**Introduction** On some ECHO, Scion xA, and Scion xB vehicles, a condition may exist that allows the evaporator drain hose to become detached, causing the passenger foot well to become wet. This bulletin provides a procedure to correct this condition.

- Applicable Vehicles**
- **2003 - 2005** model year **ECHO** vehicles produced **BEFORE** the Production Change Effective VIN shown below.
  - **2004 - 2006** model year **Scion xA** and **xB** vehicles produced **BEFORE** the Production Change Effective VINs shown below.

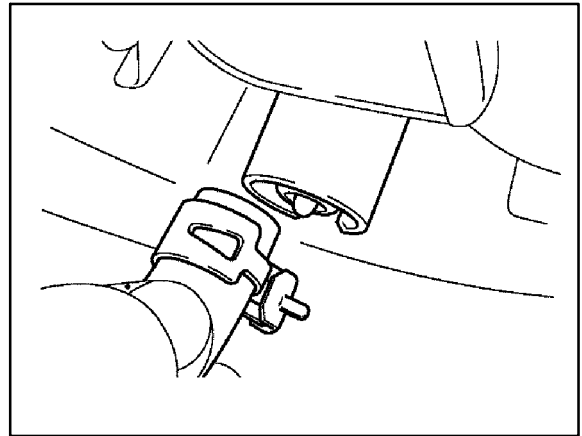
1. Inspect the evaporator drain hose to ensure that it is the cause of the water leak. If the evaporator hose is out of position, continue with this procedure.

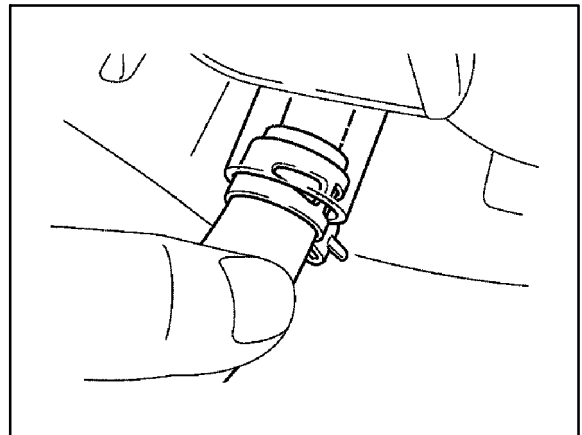
2. Install the retaining clamp on the drain hose.

3. Push the drain hose up onto the evaporator drain tube. Ensure that the drain hose is up far enough for the retaining clamp to fully engage the tube.
